RANDALL COMMERCIAL PARK SUBDIVISION

APPLICATION NUMBER 26 DATE August 16, 2007

REQUEST Subdivision

DETAIL SITE PLAN

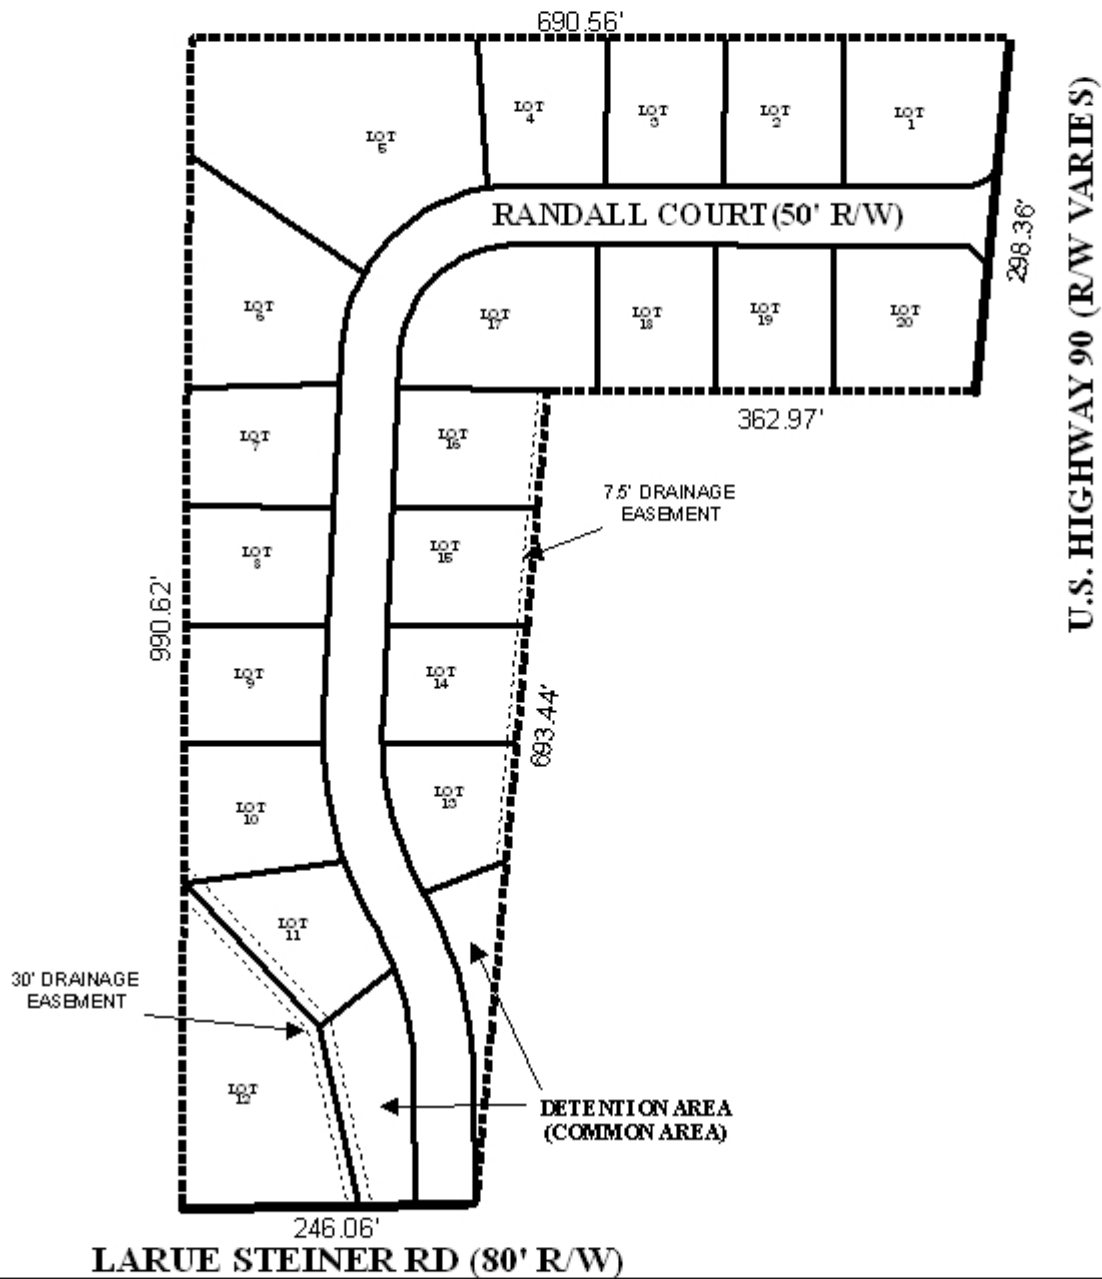
The site fronts Larue Steiner Road, which has an 80' right-of-way, and U.S. Highway 90, which has a varying right-of-way, which appears to be 180' in this vicinity. U.S. Highway 90 is illustrated on the Major Street Plan with a proposed 250' right-of-way; as such dedication of sufficient right-of-way to provide 125' from the centerline of the highway would be required, and would be satisfied by the 35' dedication shown on the plat; however, the dedication should be revised to provide dedication to Mobile County, not the City of Mobile, since the site is in the County.

The plat indicates what is probably a minimum building setback line, although it is not labeled as such; therefore, the plat should be revised to depict a 25' minimum building setback line along all street frontages. The setback line along U.S. Highway 90 should be measured from the dedicated right-of-way line.

No lot sizes in square feet were indicated on the plat; therefore the final plat should be revised to label each lot with its size in square feet, or a table depicting the same information should be provided.

As the subdivision involves the creation of a new street, construction and dedication of the street to County Engineering standards would be required. Dedication of 25' radii at the intersections with U.S. Highway 90 and Larue Steiner Road should also be required; and a temporary

turnaround at the North end of the new street should be required until such time as the new street connects to the highway. The placement of a note on the final plat stating that proposed Lots 1 and 20 are denied direct access to U.S. Highway 90 should also be required.

The plat depicts two detention/common areas; thus a note should be required on the final plat stating that maintenance of these areas will be the responsibility of the property owners.

- 1) dedication of right-of-way to provide 125' from the centerline of U.S. Highway 90, as shown on the plat;
- 2) correction of the dedication along U.S. Highway 90 to read "dedicated to Mobile County", or "dedicated to the State of Alabama";

- 3) depiction and labeling of the 25' minimum building setback line along all street frontages, with the setback along U.S. Highway 90 measured from the dedication line;

- 4) the labeling of each lot to indicate its size in square feet, or provision of a table on the plat with the same information;
- 5) the construction and dedication of the new street to County Engineering standards;

- 6) dedication of 25' radii at the intersections with U.S. Highway 90 and Larue Steiner Road;
- 7) the construction of a temporary turnaround at the North end of the new street, until the street connects to U.S. Highway 90;

- 8) the placement of a note on the final plat stating that Lots 1 and 20 are denied direct access to U.S. Highway 90;
- 9) the placement of a note on the final plat stating that maintenance of detention/common areas will be the responsibility of the property owners;
